# Review: Proportional Integral controller Enhanced (PIE) Active Queue Management (AQM) [PNB<sup>+</sup>15]

Bob Briscoe\*

08 May 2015

Figure 1: Comparison of Proposed Autotuning Function with Look-Up Table Approach

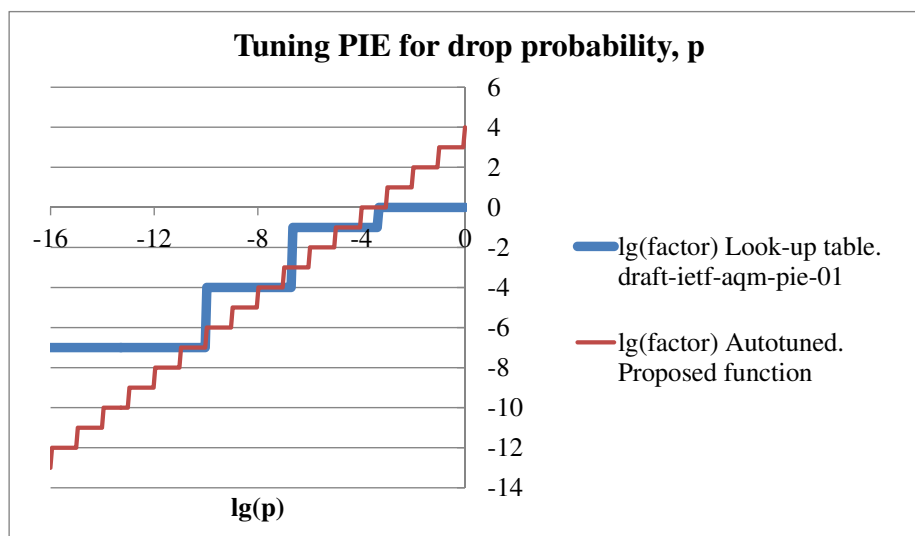
Anyway, that look-up table is surely unnecessary. Below I’ve repeated the look-up table of  $p$  against ‘factor’ from the draft and added more columns to show that the factors in the look-up table approximate to a linear relationship with  $p$  (compare  $p_{\text{mid}}$  and  $\text{factor}/16$ ). This is not surprising because the draft says that the factors were chosen so that the changes in  $p$  were proportionate to the size of  $p$  before the change.

with ALPHA\_DEFAULT = 16? It’s a decent approximation of the look-up table of factors in the draft, particularly given the draft says that the exact values of the factors are not critically sensitive. Importantly, it continues indefinitely as  $p$  gets smaller, whereas the look-up table approach always stops somewhere (see Fig 1).

So, why not just set

$$\text{factor} = p * \text{ALPHA\_DEFAULT}$$

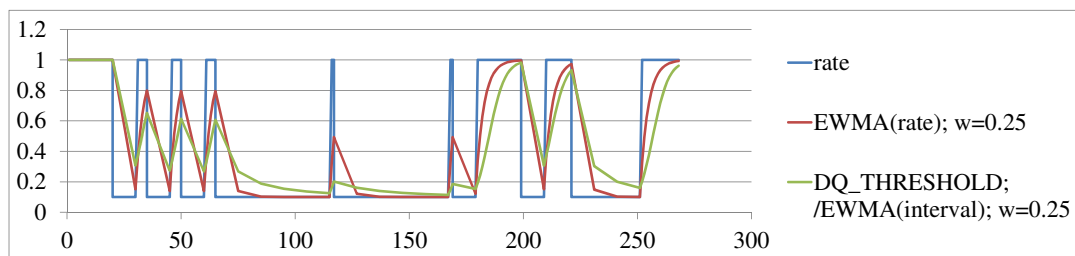
The queue is only sampled and  $p$  is only updated once every `T_UPDATE` (= 16ms by default). This might be appropriate for properly ACK-clocked or paced long-running flows. However, more bursty traffic is often the norm, with lots of short flows arriving at irregular intervals. In such bursty scenarios, the queue will tend to vary rapidly, so numerous samples will be needed to characterise the average queue. By spacing samples so widely apart, it seems likely to take a very long time for  $p$  to reach an appropriate value, by which time it will probably no longer be appropriate.

PIE's sampling rate might be appropriate to minimise processing on cost-reduced equipment like a residential gateway for a link rate of say 8Mb/s (it then equates to about one in ten 1500 B packets). But, even then, it seems unnecessarily infrequent. The draft should explain the tradeoffs that were made before settling on this sampling rate, and whether evaluations have shown that a shorter sampling time (if feasible) would be beneficial?

The draft says "Given modern high speed links, this period translates into once every tens, hundreds or even thousands of packets." However, it seems that the benefit of reducing background processing beyond tens of packets becomes insignificant compared to the sloppiness of such infrequent updates to  $p$ .

Figure 2: Exponentially Weighted Moving Average vs. PIE's Non-EWMA Approach for an Example Sequence of Rate Variations

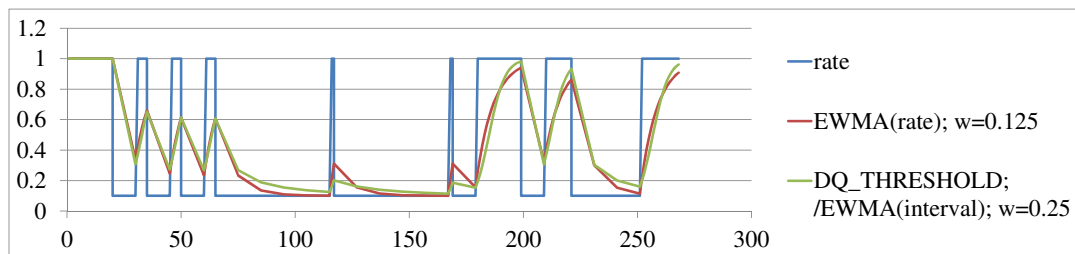
However, taking an exponentially weighted moving average (EWMA) of the dequeue times in the denominator is not the same as taking the EWMA of the rates. The pseudocode continually measures the sequence of dequeue times,  $t_1, t_2, t_3, \dots$  that it takes to transmit constant amounts of bytes (DQ\_THRESHOLD). Then the exponentially weighted moving average (EWMA) of the rate should be:

Fig 2 compares a correctly calculated EWMA with the non-EWMA in the PIE draft. They are both shown averaging the departure rate of a link that varies between 1 unit and 0.1 units for the same sequence of example durations. For the record, the formula for the correct EWMA is:

The top chart (2a) shows that the PIE approach is considerably slower to converge than the correct EWMA with the same weight (1/4 in both cases). In the bottom chart (2b), the weight of the correct EWMA has been scaled down to 1/8 in an attempt to match the outcome of the PIE approach. Looking closely it can be seen that the PIE approach is faster than exponential at first, then slower than exponential later. This explains why, whatever constant scaling is chosen, even if one part of the trace can be made to match, other parts will fail to match.

It would be hard to implement a correct EWMA unless constant time periods were used instead of constant amounts of bytes. It might still be acceptable to use the PIE formula as an approximation. However, it should be considered whether there might be pathological scenarios where the error would be unacceptable.

Figure 3: Rerandomization of Derandomized Drop Spacing

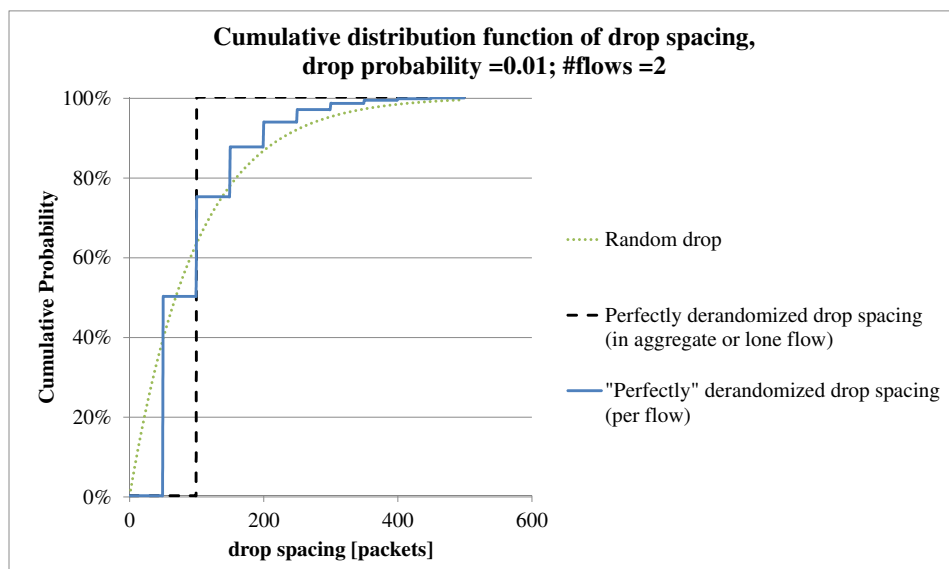
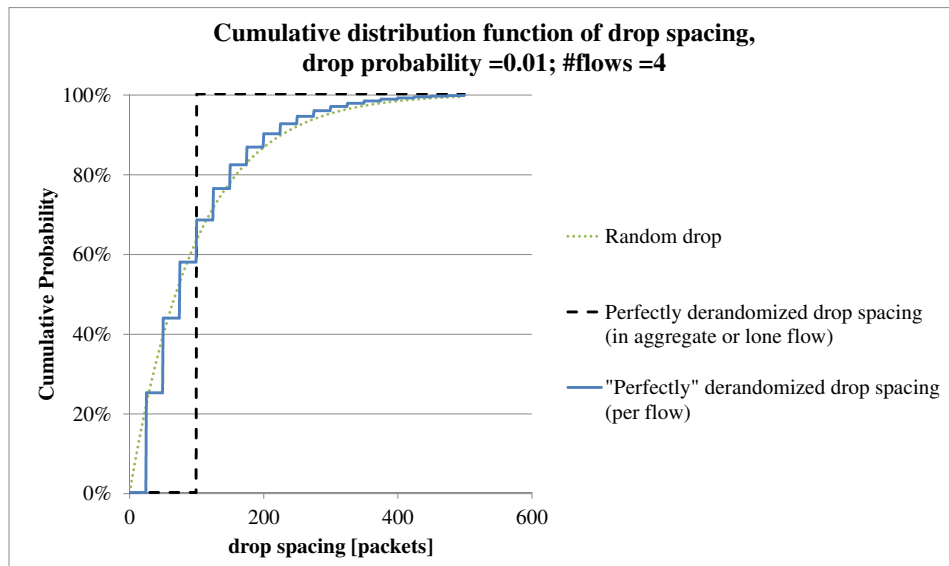
In fact, for any number of flows greater than one, if the cumulative distribution function of spacings with derandomization is laid on top of the CDF without, they follow nearly the same curve, except the derandomized one is stepped (see Fig 3). Derandomization does avoid bunching of drops, but it does not prevent some drops arriving very far apart, as the figure shows. This is true no matter how few flows there are, unless there is just one (see the lower figure for 2 flows).

In practice, the outcome of derandomization will be even more random than shown in the plots, for two reasons:
